Subject: Minutes for 57th Protection Sub-Committee Meeting.

57th Protection Sub-Committee Meeting (20th February, 2025)-MoM

**Minutes of
57th Meeting of Protection Sub-Committee (PSC) of
Northern Regional Power Committee**

On 20th November 2023 at 08:34 Hrs., during the Bipole Shutdown of HVDC Link two Type 3 Filter Banks (Z13, Z23) were taken into service at Dadri Sub-station while all other filter banks and both HVDC poles were isolated. At 08:36 Hrs., both filter banks tripped on Resistor Overload Protection.

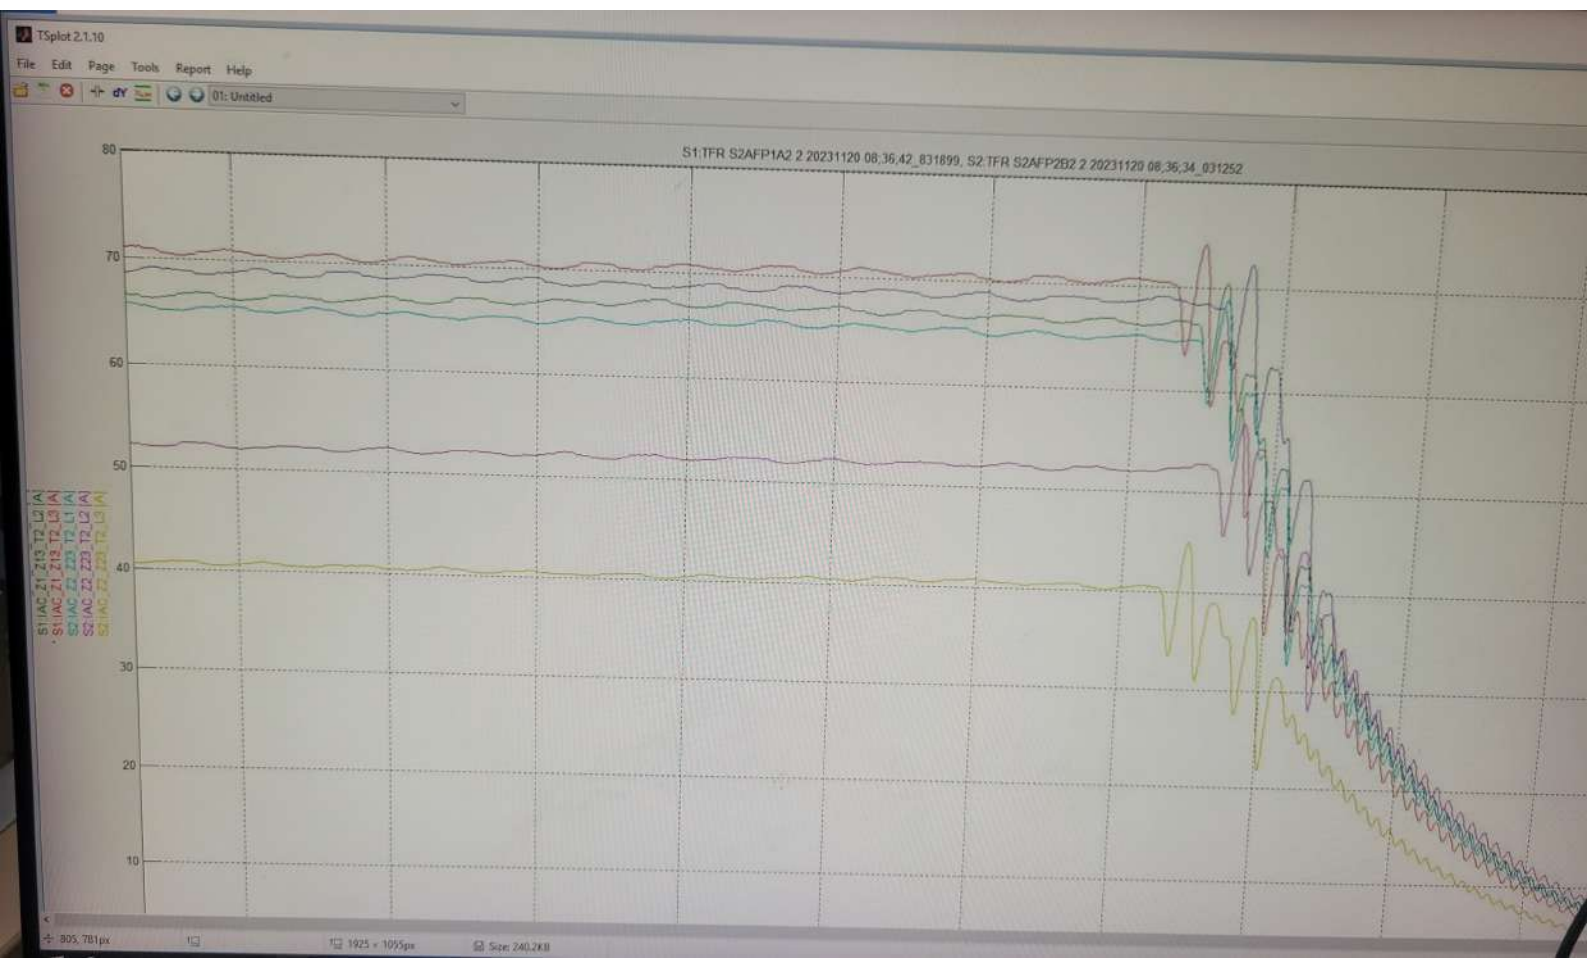
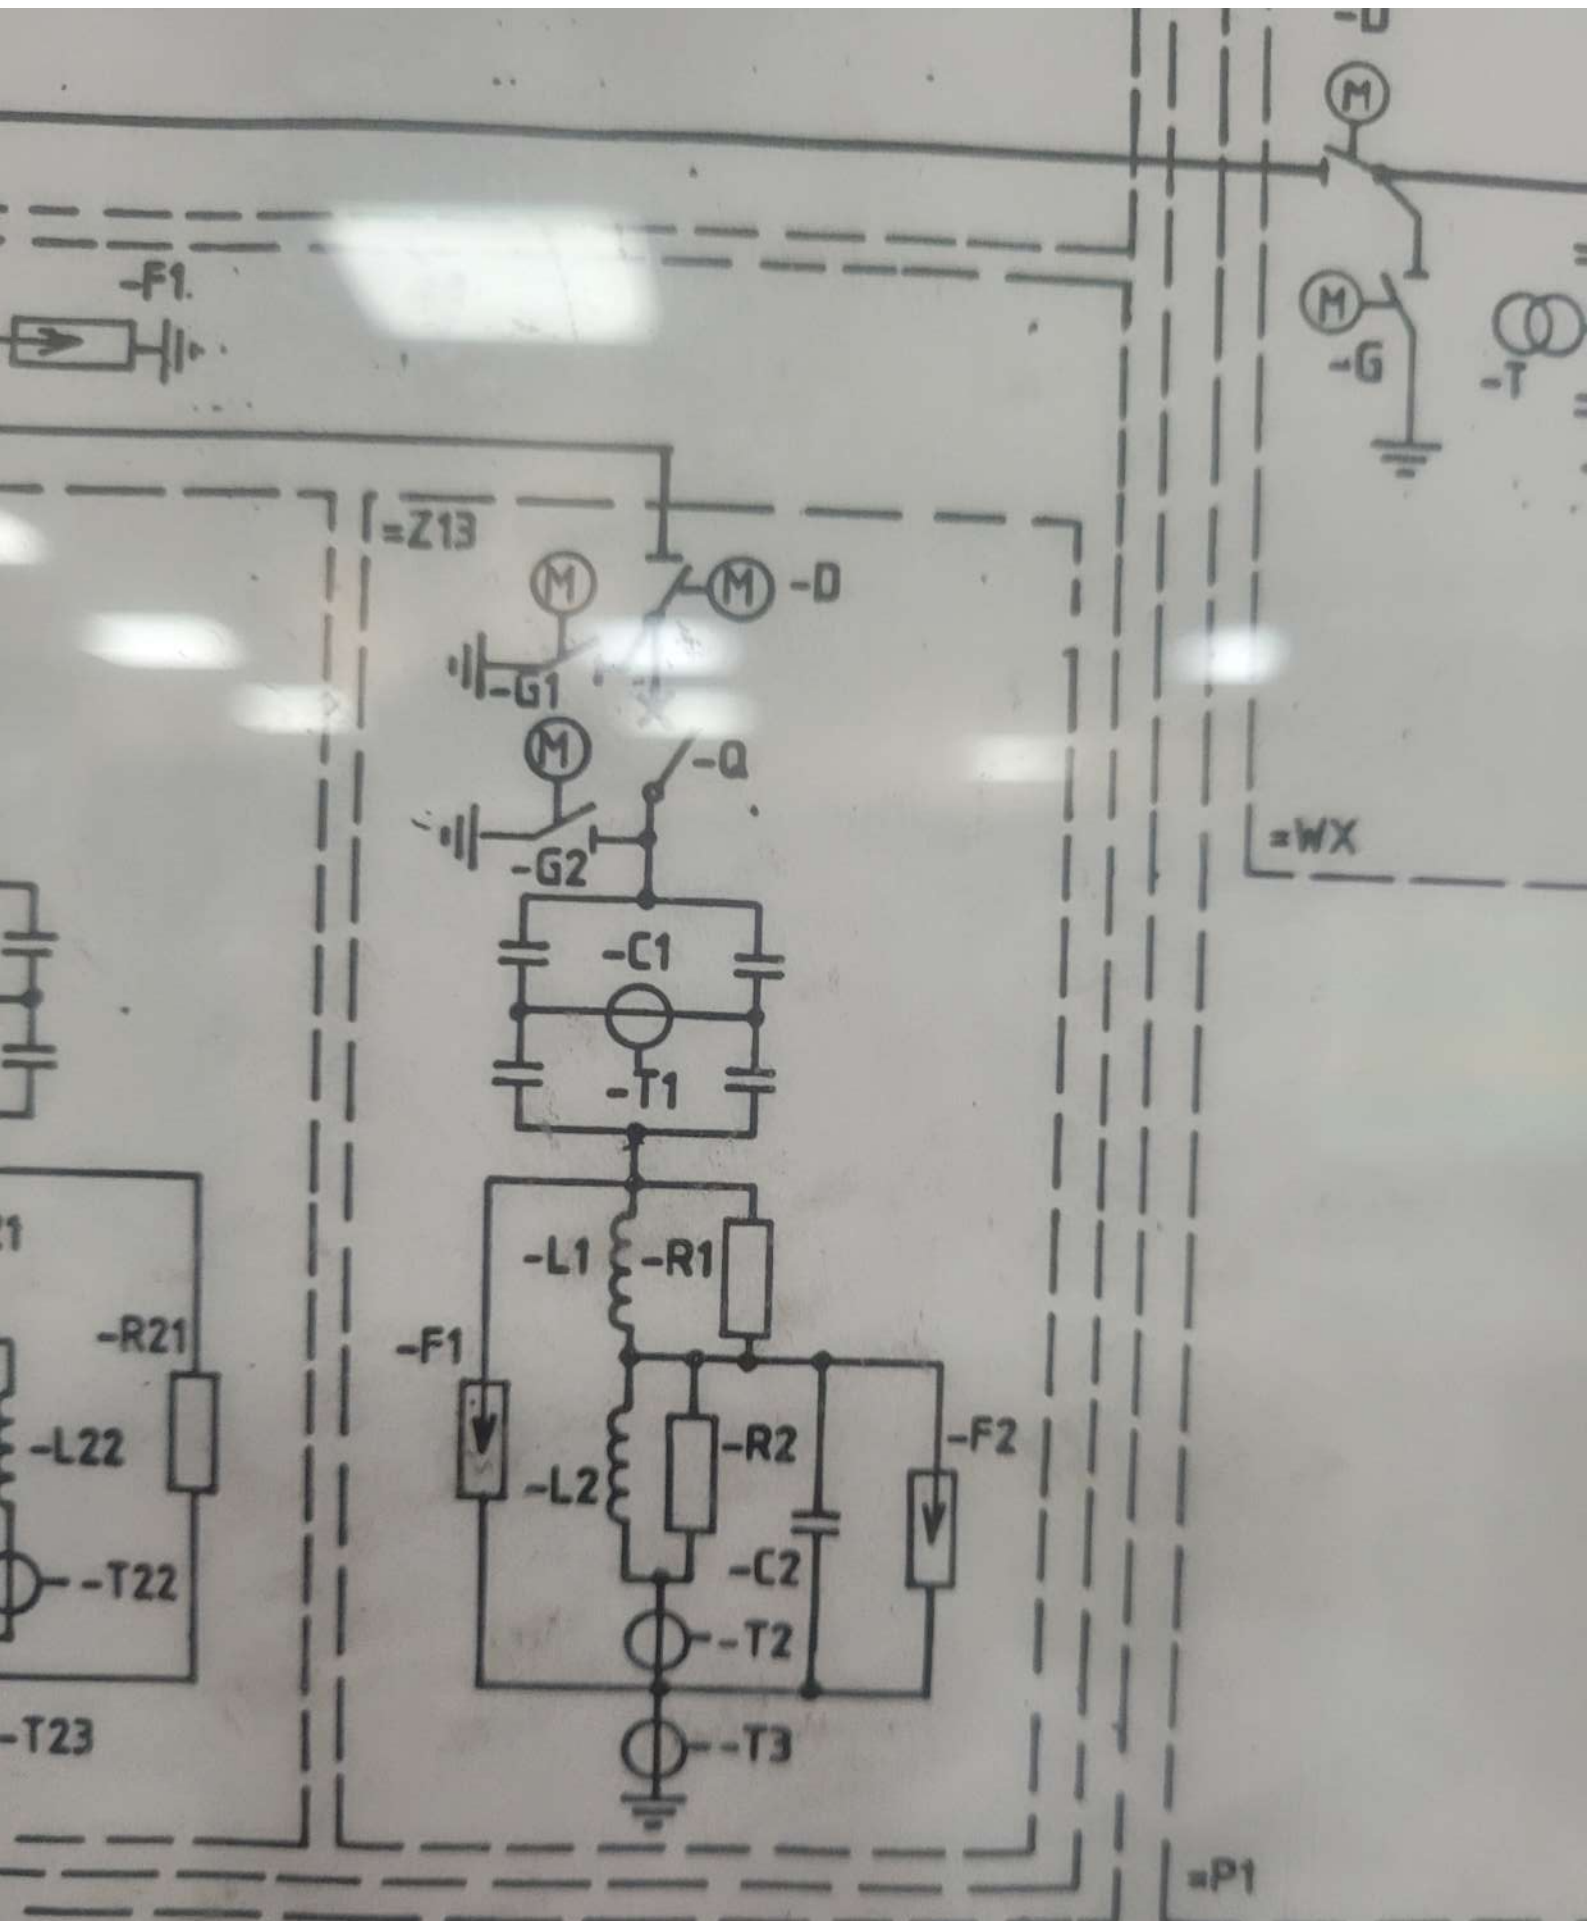
Subsequent analysis revealed a significant presence of the 5th harmonic component in the current measured on the Overload Protection CT. A detailed harmonic analysis of the current, measured at the Overload CT, is **saved in folder**. The event list and TFR associated with this tripping are also **enclosed**.

In view of the above, the issue of Type 3 Filter Bank tripping due to overload protection at the Dadri Sub-station is submitted for further discussion and resolution with NRPC.

SLD of 400/220kV Akal(RS) before the event

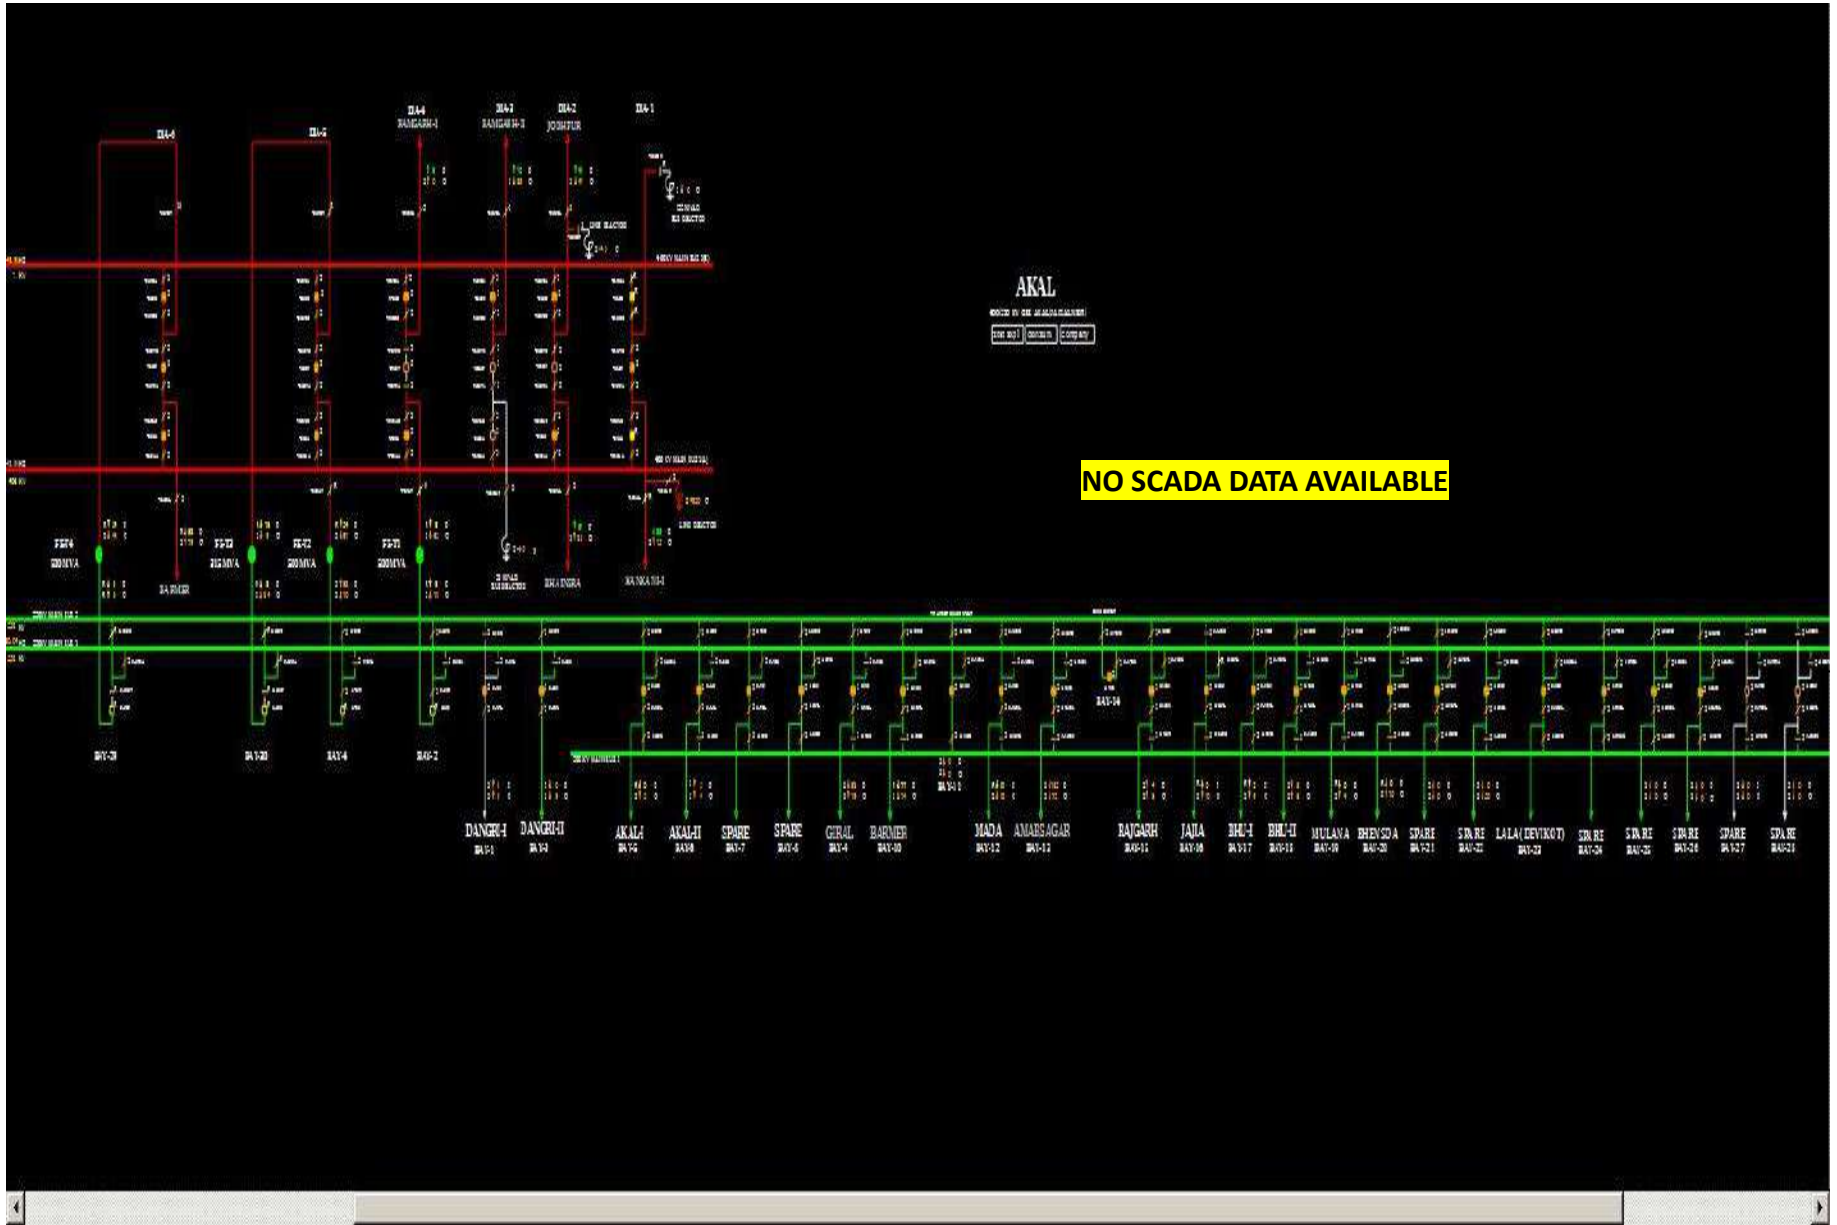
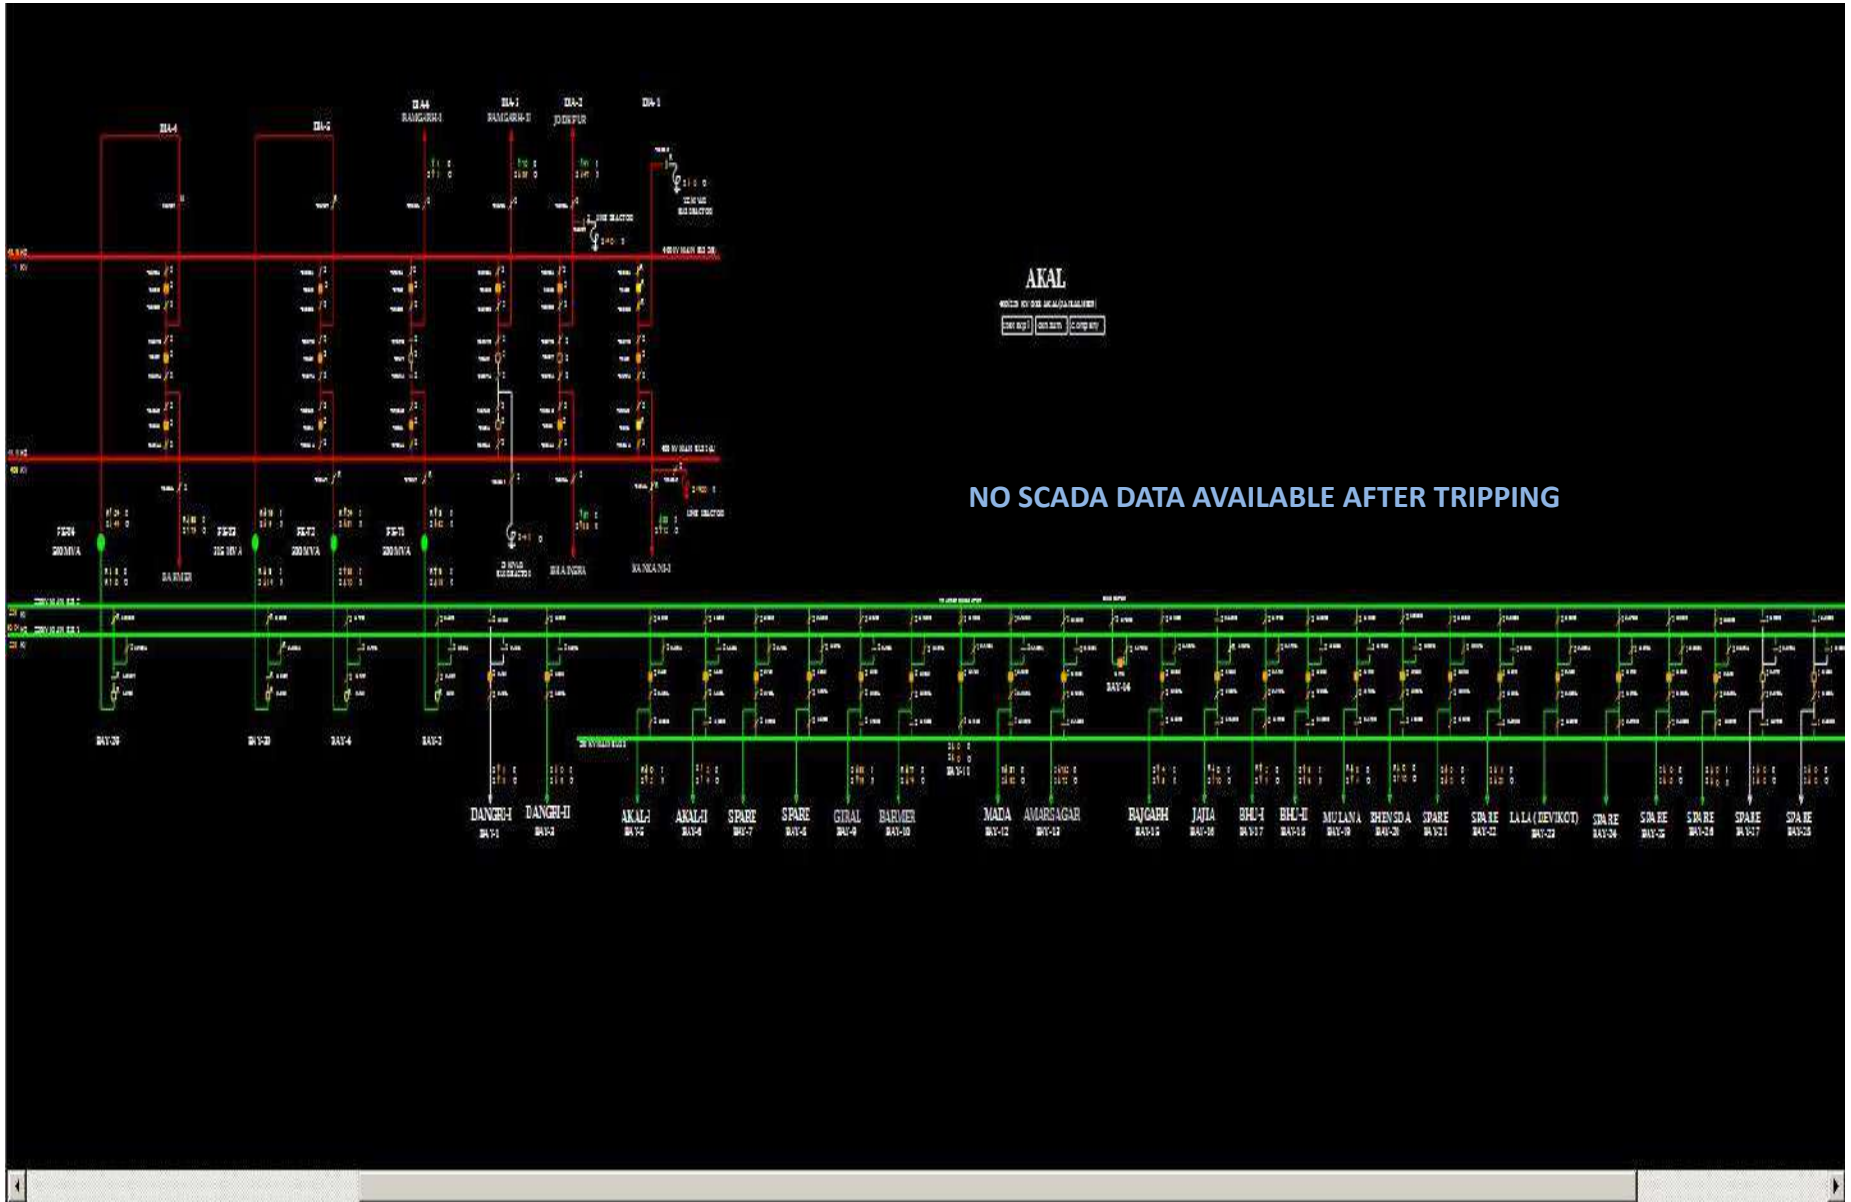
- As per SCADA, change in demand of approx. 171MW is observed in Rajasthan control area.
- **Major observations:**
 - Reason for delayed fault clearance needs to be shared.

- The CB of 220kV Akal-Bhensara Ckt-1 at Akal GSS was in Lockout condition hence it did not open at fault. LBB relay also operated for re-trip after 100 ms but the said CB did not trip.
- LBB relay supposed to provide further trip command to Busbar scheme but unfortunately at the time of fault the 220 kV Busbar protection scheme was under blocked condition because of PU error, FO cable issue, SCADA integration issue of PU etc. Hence, tripping of all local CB could not be matured through busbar protection scheme.
- **As remedial action taken, the issue in CB of 220kV Akal-Bhensara Ckt-1 at Akal GSS is attended and 220 kV Busbar protection scheme at 400 kV GSS Akal has been made operative on 15.02.2025 and in healthy condition.**
